# CROSSROADS NORTH PRELIMINARY PLAN

LOCATED IN THE EAST 1/2 OF SECTION 8, T14S, R65W, OF THE 6th P.M., EL PASO COUNTY, COLORADO

# Prelim Plan V\_1 redlines.pdf Markup Summary 12-18-2020

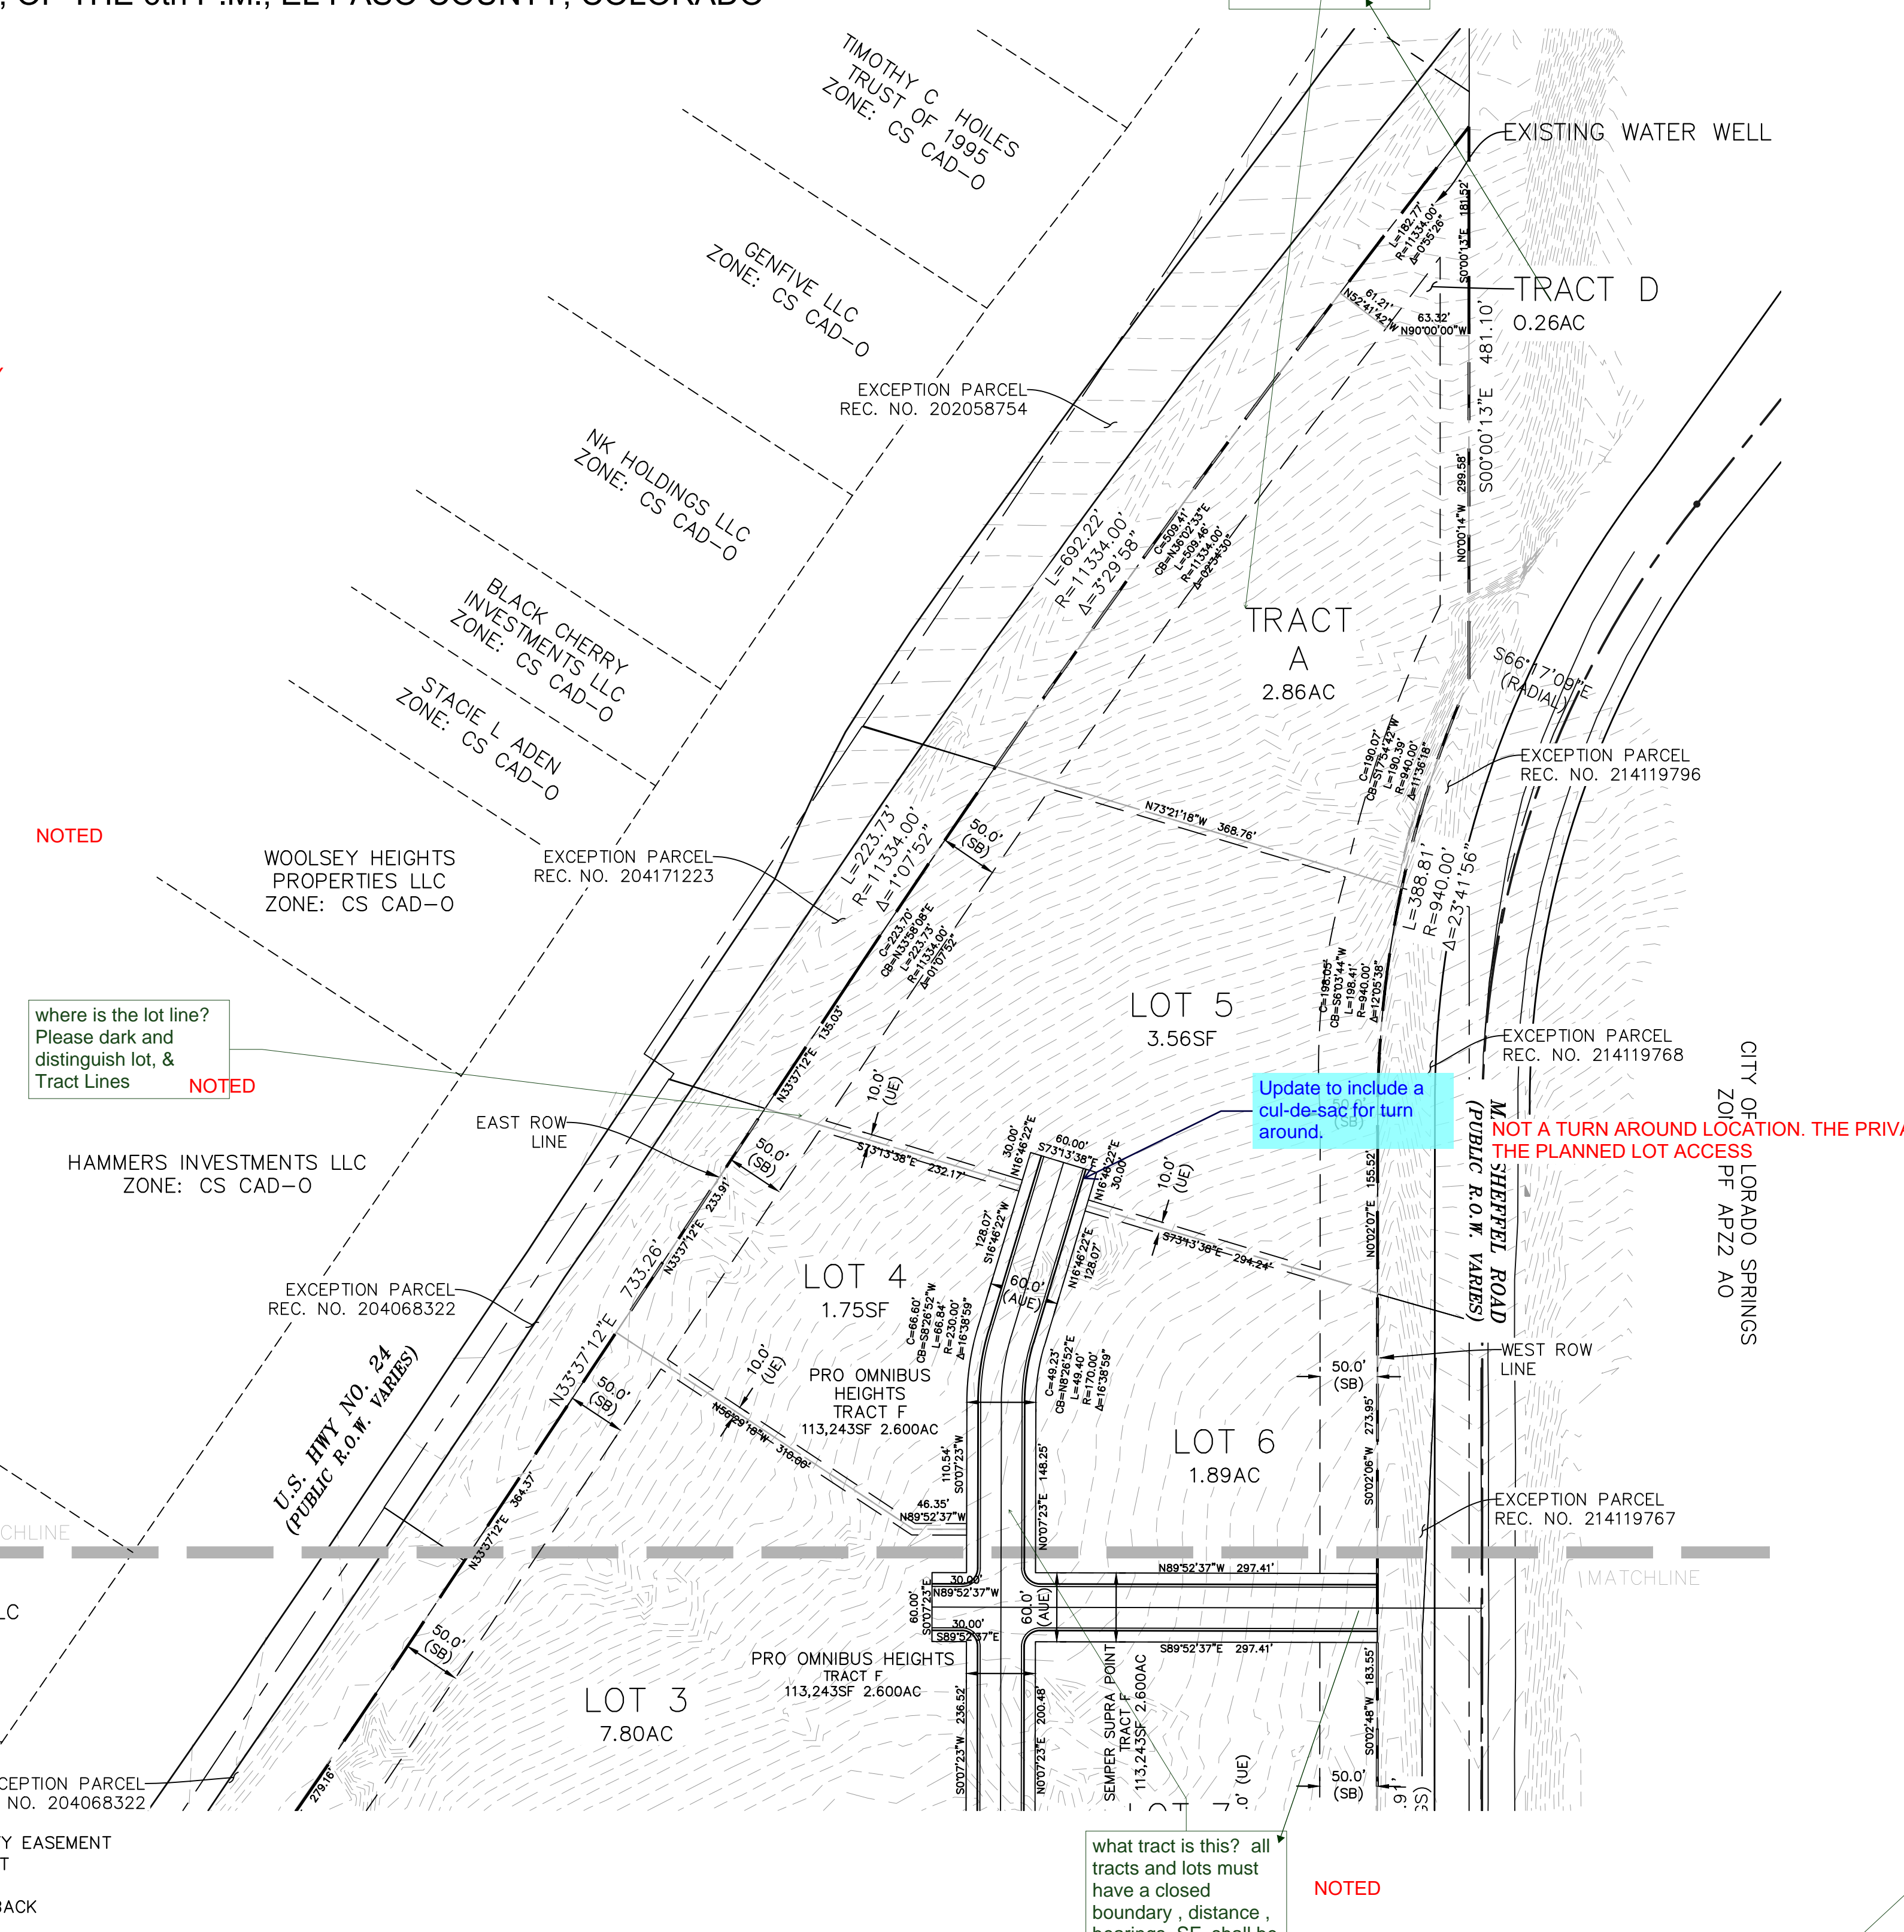
one lot table per  
prelim plan  
please....we do not  
need to repeat  
information.

state what these tracts are  
purposed for? are any future  
development? Tracts shown in  
Drainage report clearly are not  
intended for pedestrians to walk  
about it so its not landscape /  
openspace and are utility's in  
the drainage tracts allowed ? ....

if one drives on its not open  
space/ landscape- is also likely  
not a drainage pond NOTED

Crossroads Metro District 2- correct? identify name at least once...NOTED

please specifically show trails/sidewalks in tracts that are specifically for pedestrian facilities- i don't think that's the case for all tracts? Are here sidewalks adjacent to private road tract or within them? NOTED

there are multiple checklist items missing- please NOTED

All Sheets should have this info for every prelim plan submitted to County at a minimum... NOTED

what is this for- its not detention based on GEC plan? Is there 2 tracts? I can't see boundary lines or lot lines?

what tract is this? all tracts and lots must have a closed boundary, distance, bearings, SF, shall be shown for each. put label in side so we know which segment is which please.. NOTED

NOTED AND REVISED ACCORDINGLY

NO PONDS ON SITE, BUT SITE CONVEYS RUNOFF  
TWO TRACTS (A&D) CLARIFIED ON RESUBMITTAL

# CROSSROADS NORTH PRELIMINARY PLAN

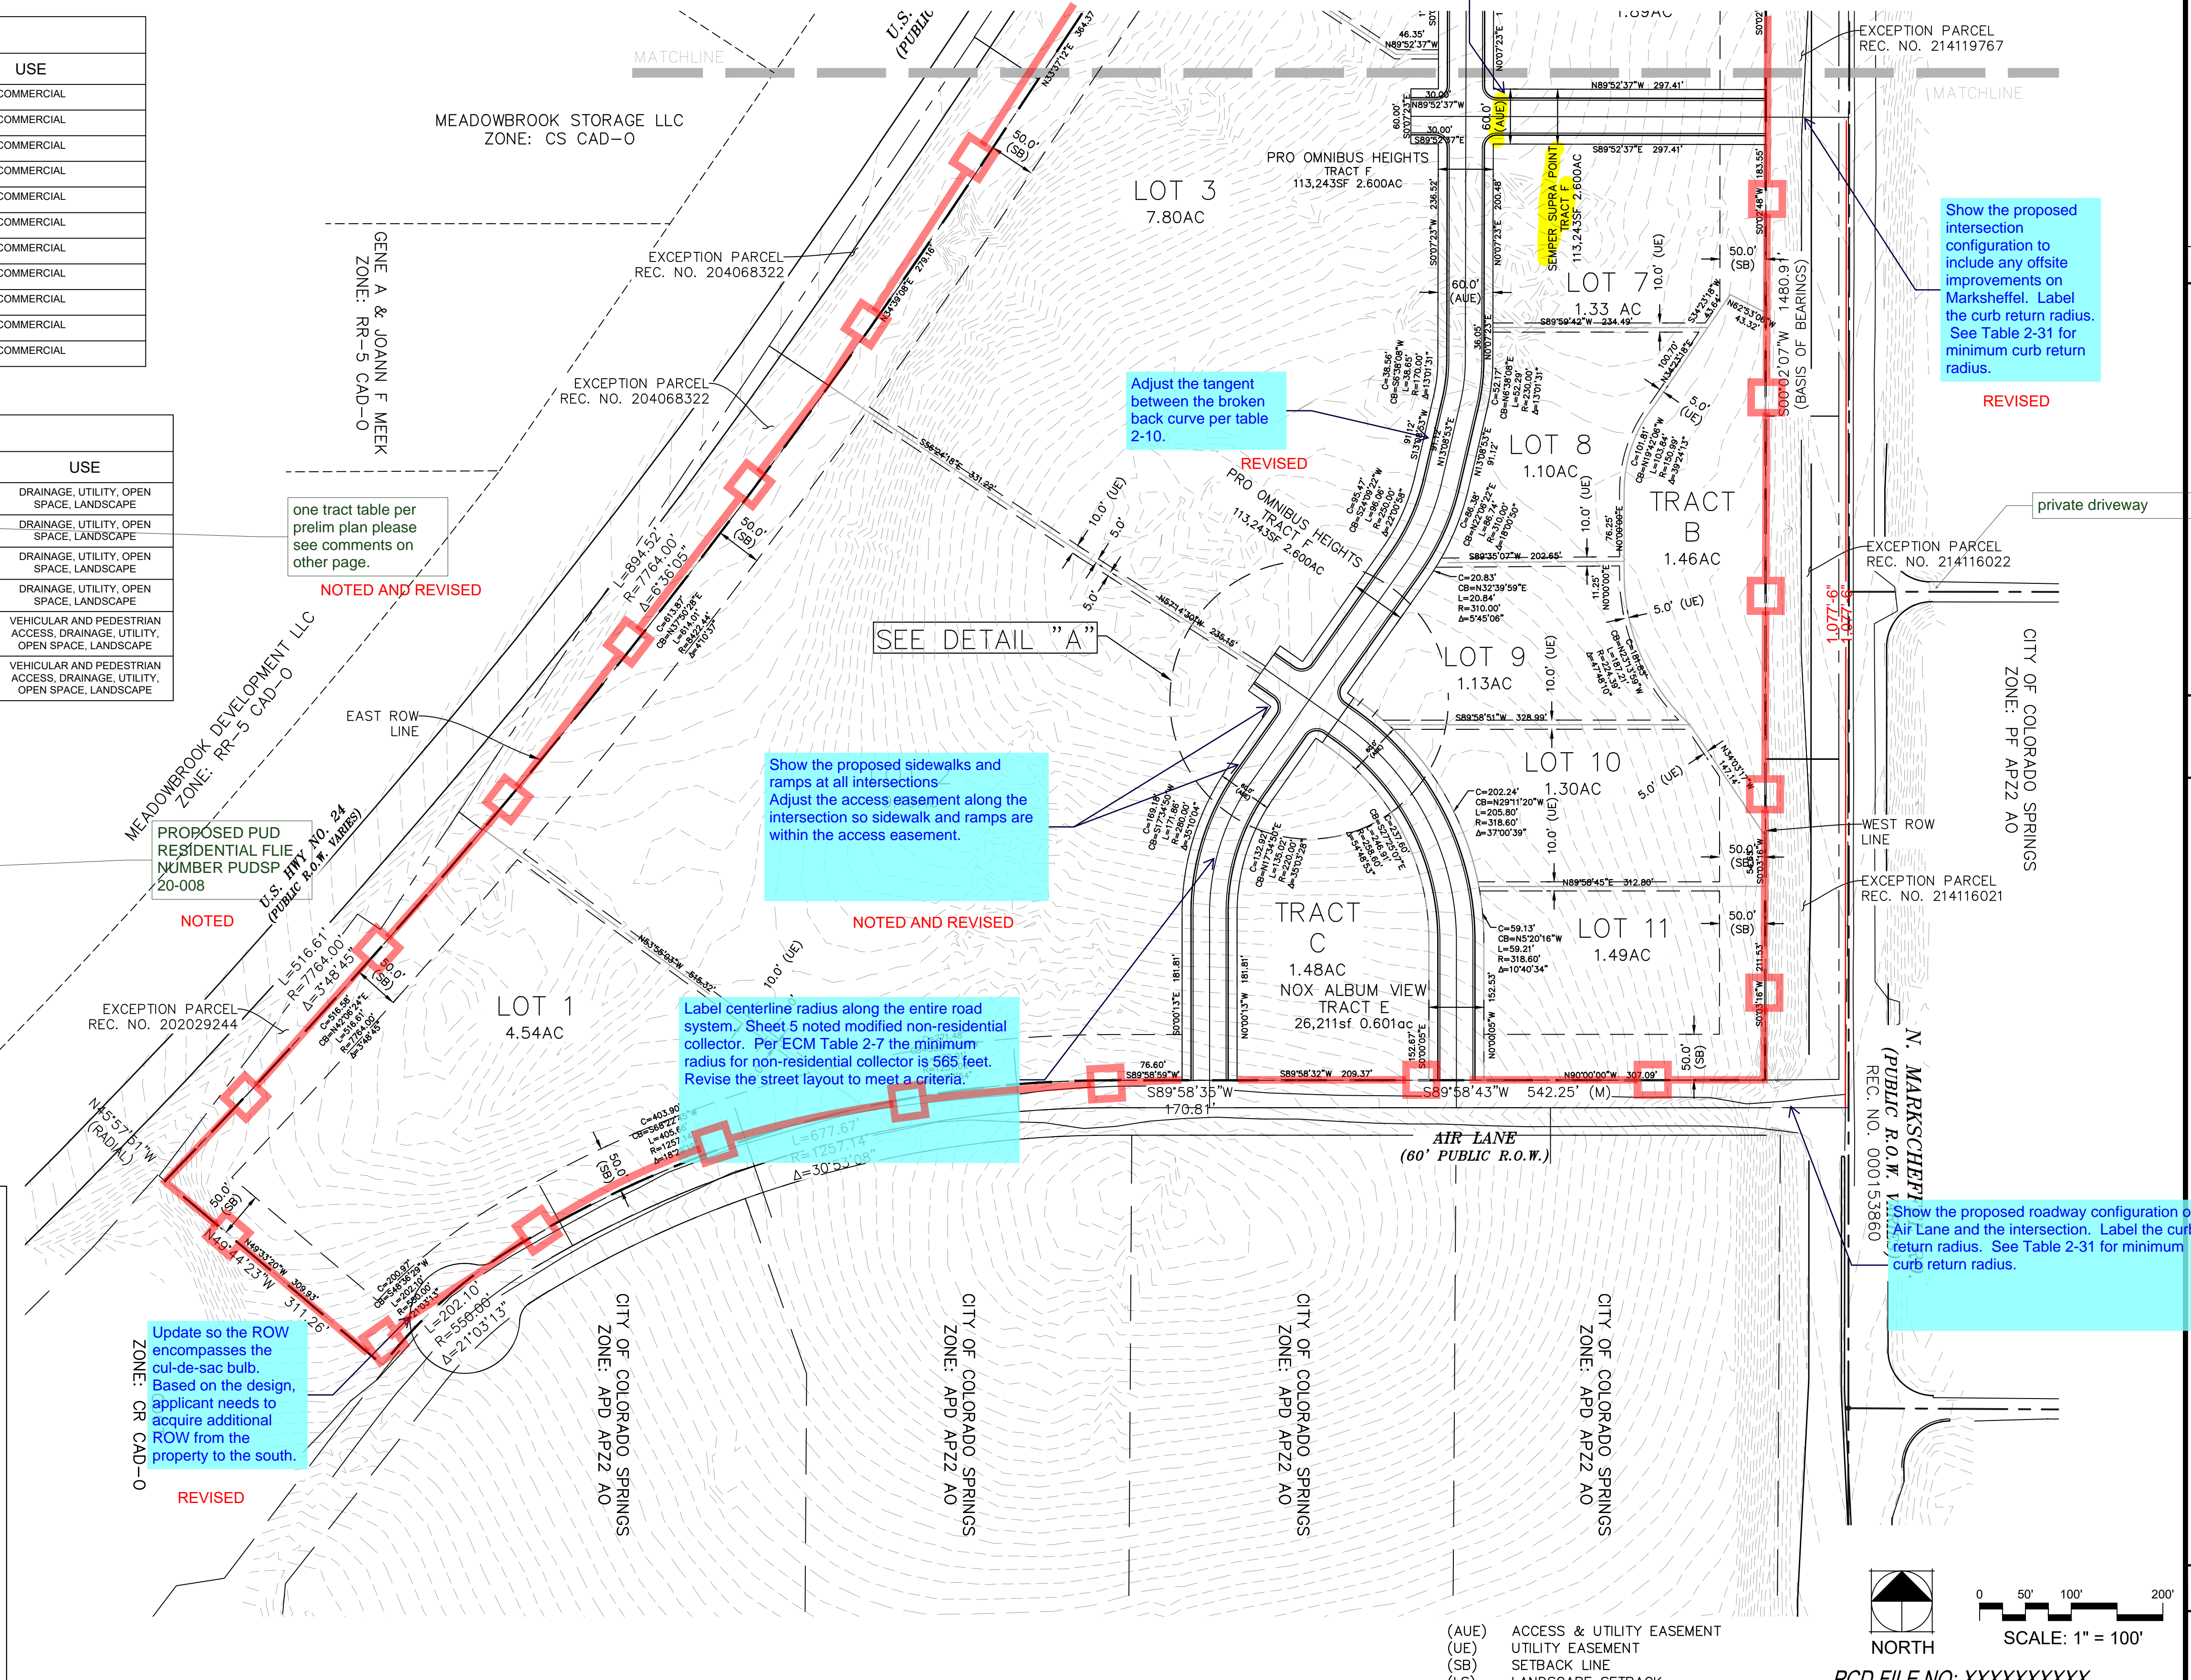
This appears contradictory. The roads are both identified as tract and easement. **NOTED**

one tract table per prelim plan please see comments on other page. **NOTED AND REVISED**

Adjust the tangent between the broken back curve per table 2-10. **REVISED**

Show the proposed intersection configuration to include any offsite improvements on Marksheffel. Label the curb return radius. See Table 2-31 for minimum curb return radius. **REVISED**

Show the proposed sidewalks and ramps at all intersections. Adjust the access easement along the intersection so sidewalk and ramps are within the access easement. **NOTED AND REVISED**

Label centerline radius along the entire road system. Sheet 5 noted modified non-residential collector. Per ECM Table 2-7 the minimum radius for non-residential collector is 565 feet. Revise the street layout to meet a criteria. **NOTED AND REVISED**

Update so the ROW encompasses the cul-de-sac bulb. Based on the design, applicant needs to acquire additional ROW from the property to the south. **REVISED**

Show the proposed roadway configuration of Air Lane and the intersection. Label the curb return radius. See Table 2-31 for minimum curb return radius. **NOTED AND REVISED**
